PLANNING COMMISSION STAFF REPORT

EDGAR H. FISCUS FARM SUB. – DESIGN PLAN #678-2024

Re: Edgar H. Fiscus Farm Subdivision – Design Plan Review Letter

DIMENSION PLAN
1374 S.R. 125
BAYLOR'S MILITARY SURVEY #511
BATAVIA TOWNSHIP
CLERMONT COUNTY, OHIO

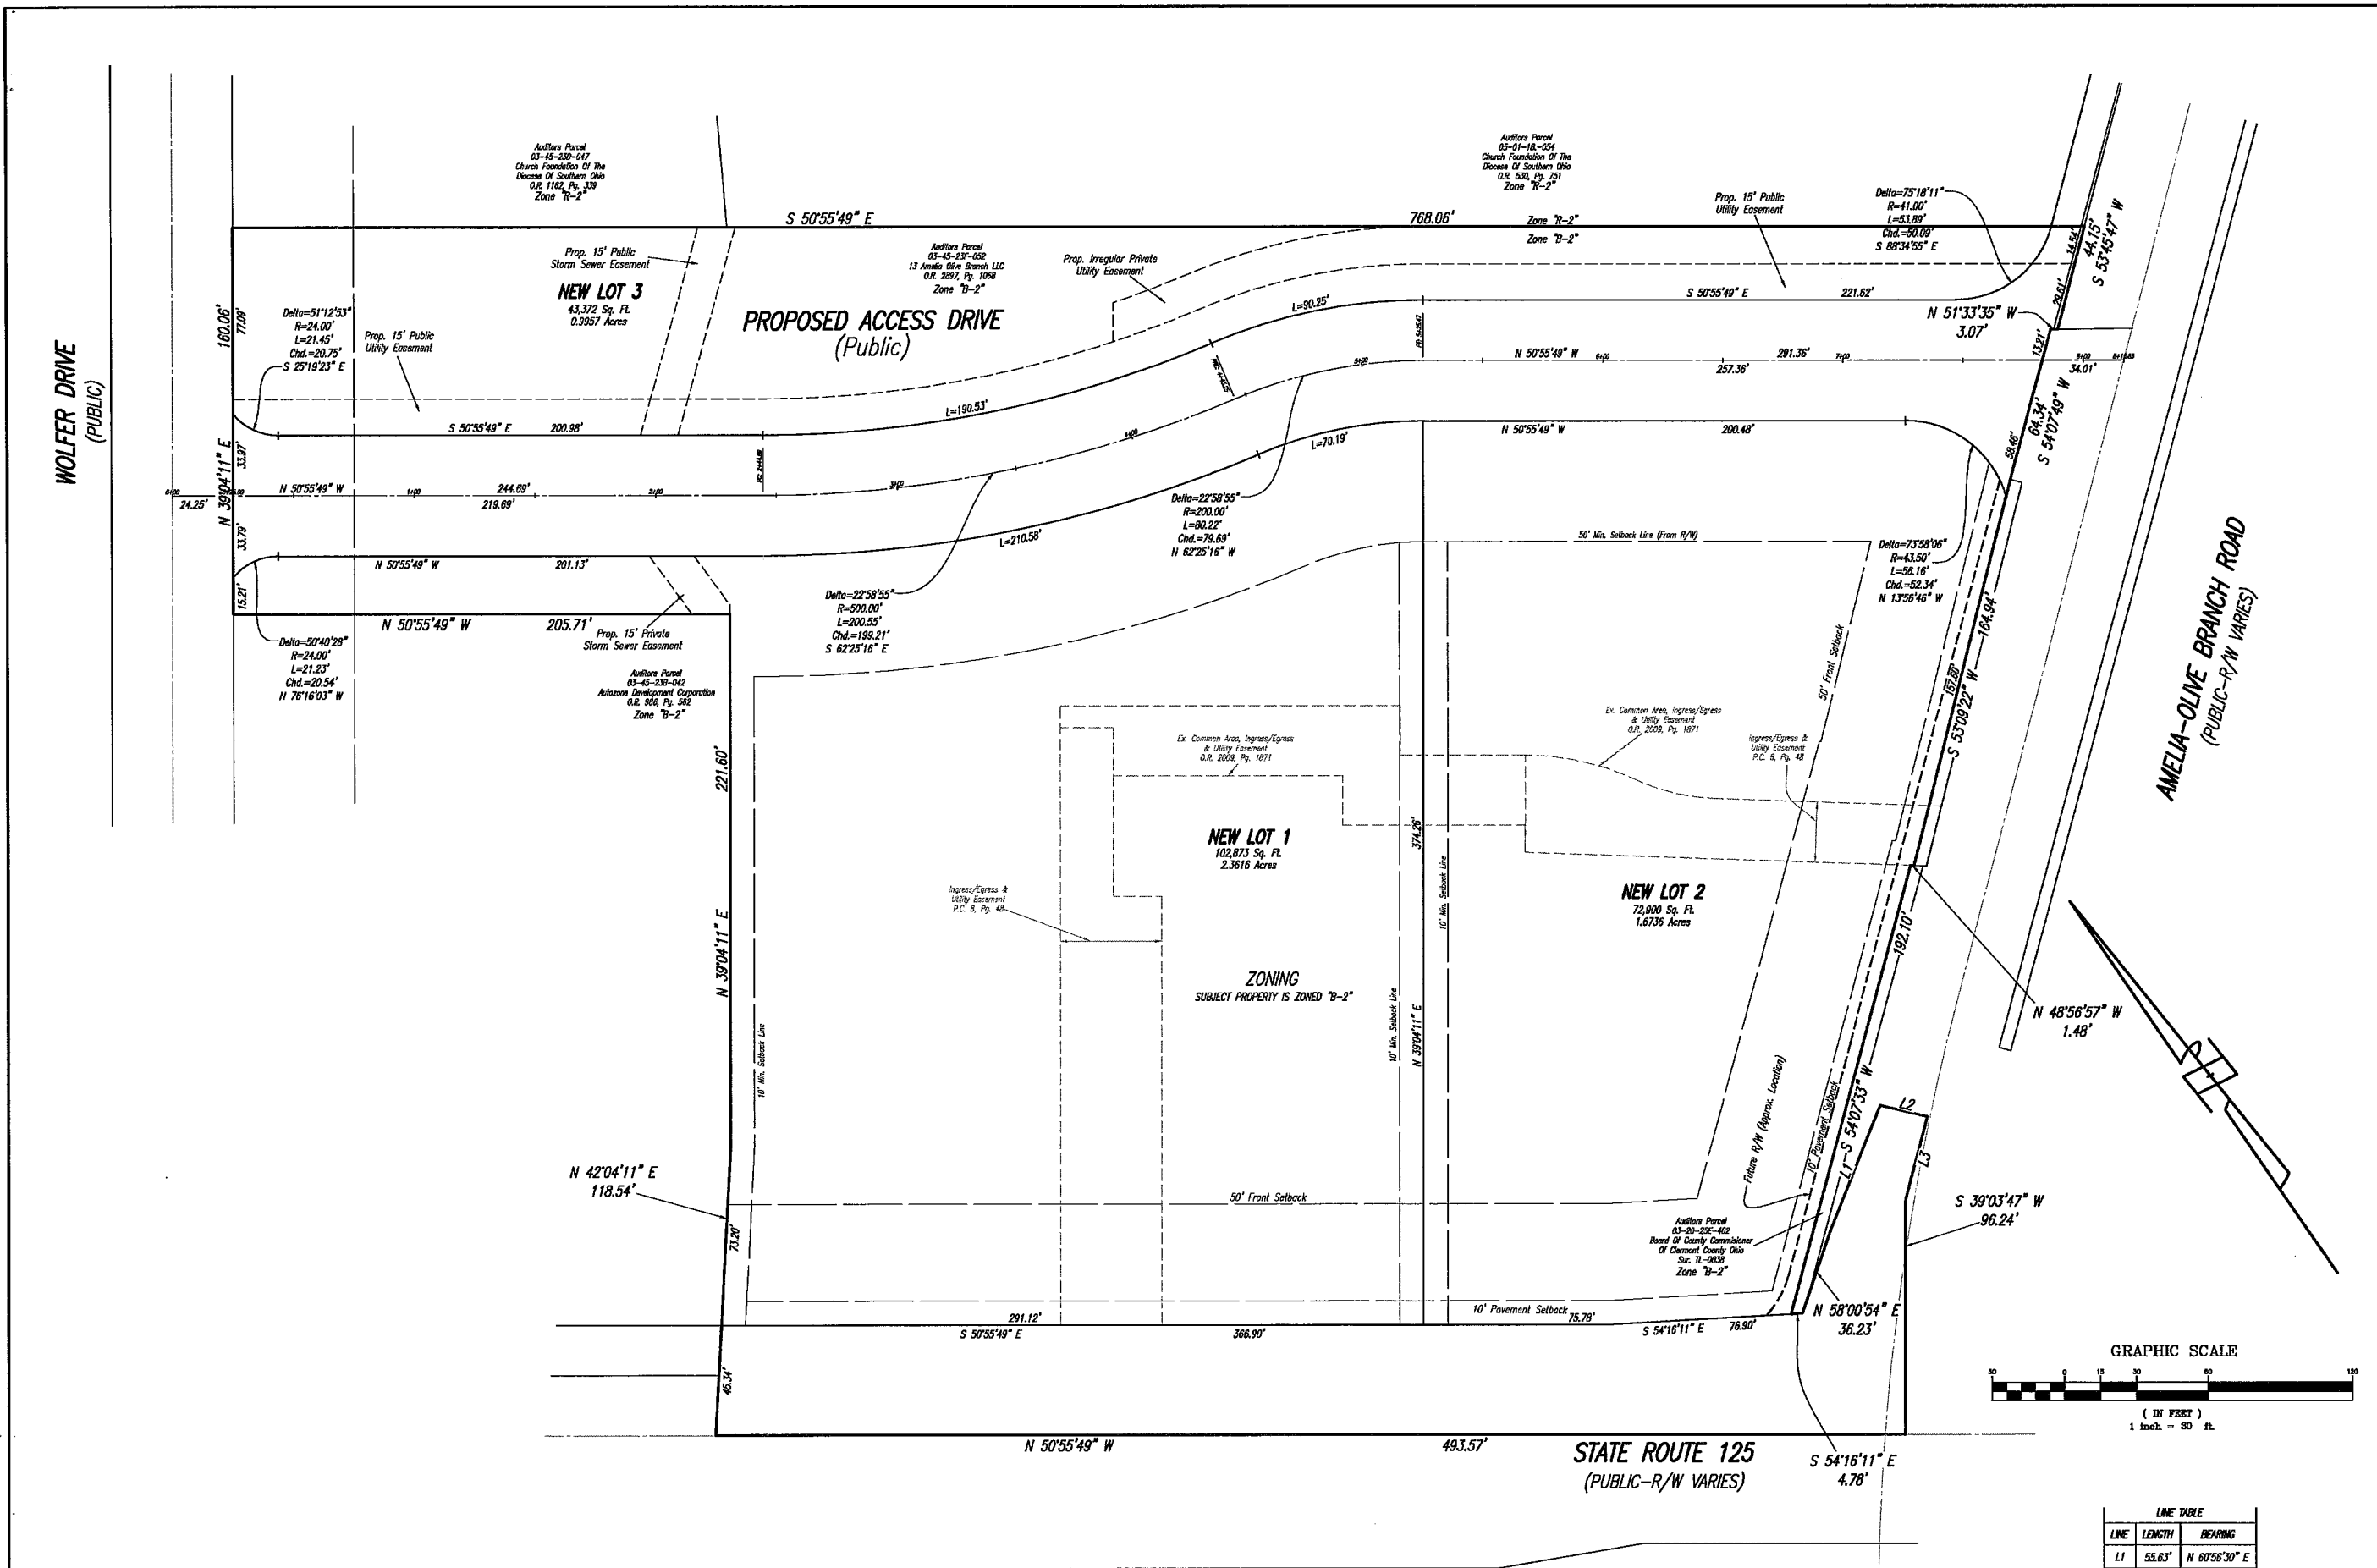
1. Change title sheet from “Construction Plan” to “Design Plan”, include military survey in title.
2. The application states that this subdivision will include 3 total lots, 1 unit, and 3 single-family. Please clarify this in the application and on the plan sheets in regards to lots, land use, and zoning allowances.

3. The owner and applicant on the application of the design plan is different than the owner and applicant on the plan set, these should be the same.
4. Indicate proposed name and width of access drive, Article 6 states 28’ of minimum required pavement width, and 50’ of minimum required dedicated right-of-way.

5. Include verification that the proposed entrances meet all applicable Sight Distance requirements as established in by the Clermont County Engineer and ODOT.

6. Include locations and dimensions of rights-of-way to be dedicated within the proposed subdivision and along any adjacent roadways.
7. Indicate any street lighting on site, Planning Commission may require it if deemed appropriate for public safety.

4. Remove all references to "Public" and "Private" from the proposed utility and storm sewer easements.
5. The Proposed Irregular Private Utility Easement needs to be removed from the plans.

8. The proposed storm sewer easements need to be Twenty (20) Feet wide.
9. The geometry of the Wolfer Drive Intersection needs to be labeled upon the plans.

10. Headwalls within the Public Right-of-Way need to be ODOT HW2.1 (Half) Headwalls. Be sure to include a detail upon the plans.
11. Additional catch basins need to be provided along the proposed public access drive. The maximum catch basin spacing is 350 Feet. Additional Catch Basins need to also be provided at Amelia-Olive Branch Road, and at Wolfer Drive Intersections. This can be addressed during the construction plan review.
